SCHWEIZER SERVICE BULLETIN

*B-237.1
30 May 1991

SUBJECT: POSSIBLE RESTRICTION OF CYCLIC PITCH CONTROL

MODELS AFFECTED: Model 269C Helicopters with Serial Numbers 0004 through 1456

Figure B-237.1-1. Spacer tube installation, Lower Longitudinal Cyclic Control Rod Assembly

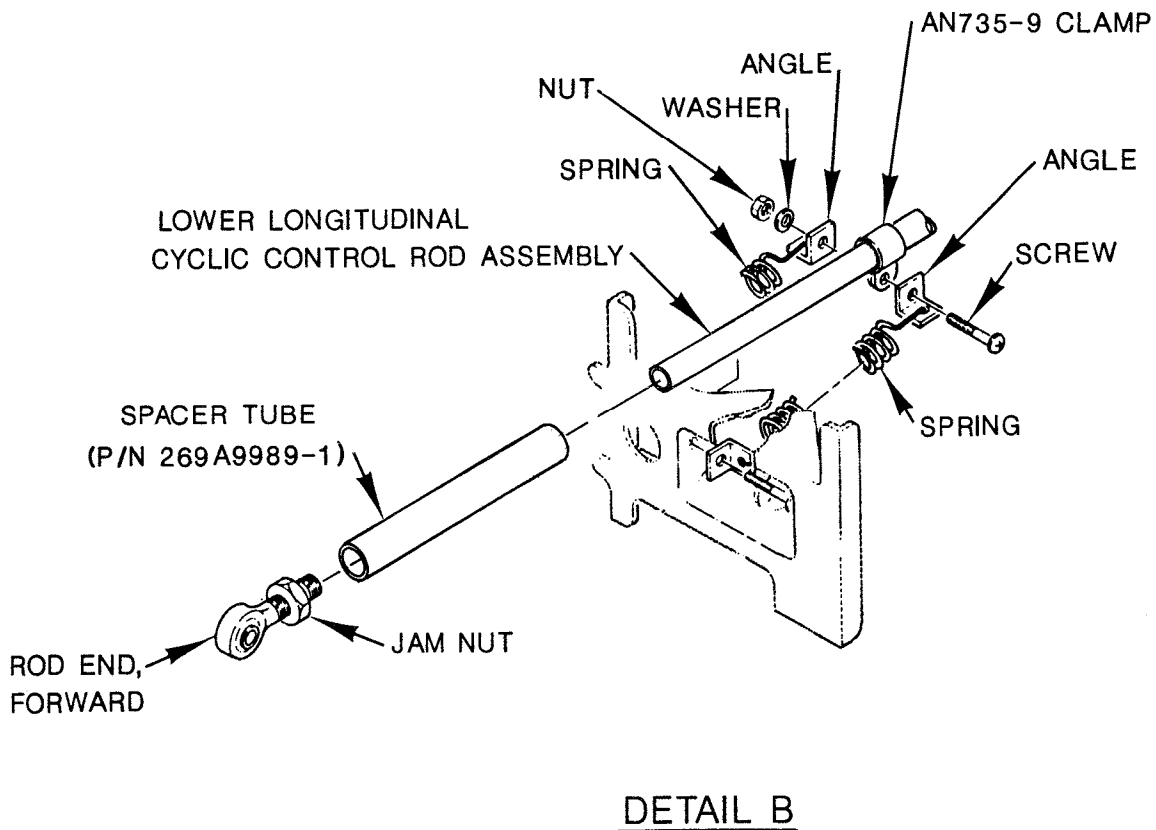
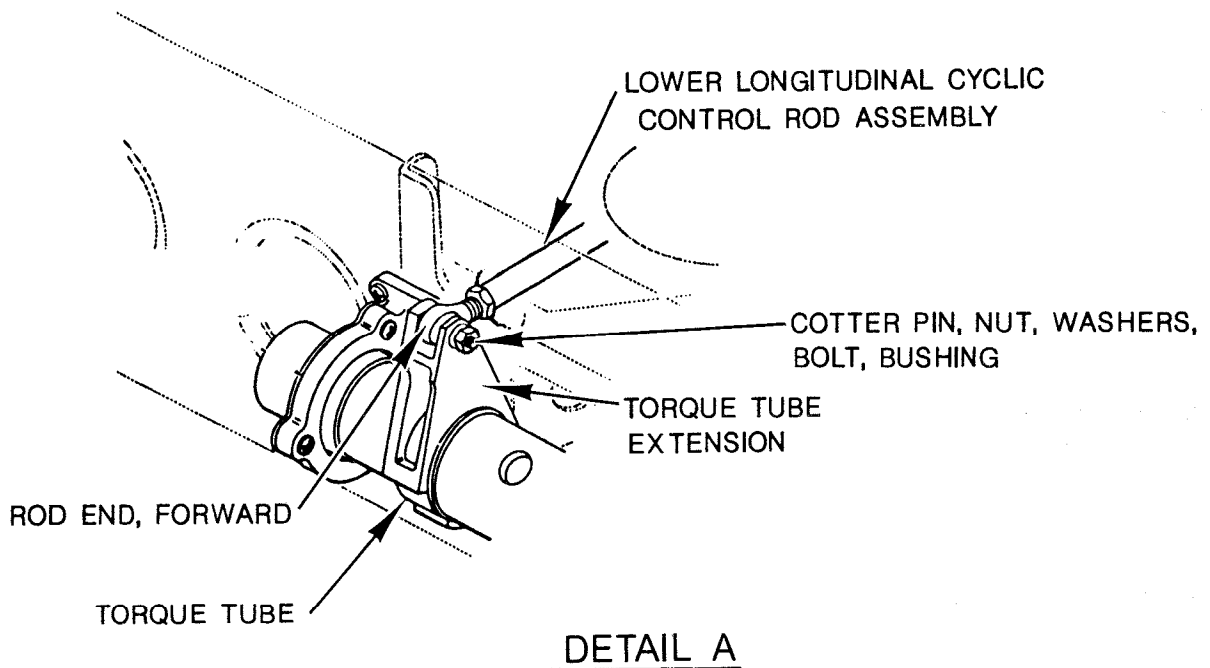
- PREFACE:
- Field reports indicate that slippage of the lower longitudinal cyclic control rod spring attachment clamp (AN735-9) on control rod assembly (P/N 269A9940-7) has occurred. This slippage may result in restriction of cyclic flight controls which could lead to a loss of control of the helicopter and subsequent personal injury or death.
 - Part I provides instructions for installation of a worm clamp on the control rod assembly to prevent slippage of attachment clamp (AN735-9), and a periodic inspection of the worm clamp installation.
 - Part II provides instructions to slide a spacer tube over the control rod assembly to prevent slippage of attachment clamp (AN735-9). This is an alternate procedure to Part I and does not require a periodic inspection.

- c. Loosen jam nut (Figure B-237.1-1, Detail B). Unscrew and remove forward rod end from control rod, counting the turns carefully.
- d. Remove worm clamp forward of AN735-9 clamp on control rod (B-237) if installed. (Worm clamp not shown on Figure B-237.1-1.)

- e. Disconnect springs, and loosen screw and nut on AN735-9 clamp.
- f. Slide spacer tube (P/N269A9989-1) over control rod. The spacer tube must slide aft far enough to clear forward end of control rod. If necessary, slide AN735-9 clamp aft to allow clearance.

- g. Install forward rod end in original position in control rod, using the same number of turns required for removal.
- h. Connect forward rod end to torque tube extension, using hardware removed in step b. above. Torque nut in accordance with BHMI, Section 2, Table 2-3, and install cotter pin.

- i. Tighten jam nut against rod end, and torque jam nut in accordance with BHMI, Section 2, Table 2-3.
- j. Slide the clamp assembly forward until AN735-9 clamp contacts spacer tube (P/N 269A9989-1). Position horizontal legs of angles parallel to control rod, and align with each other. While ensuring no movement of parts, torque nut to 20 - 25 in.-lbs. Reconnect springs to angles.
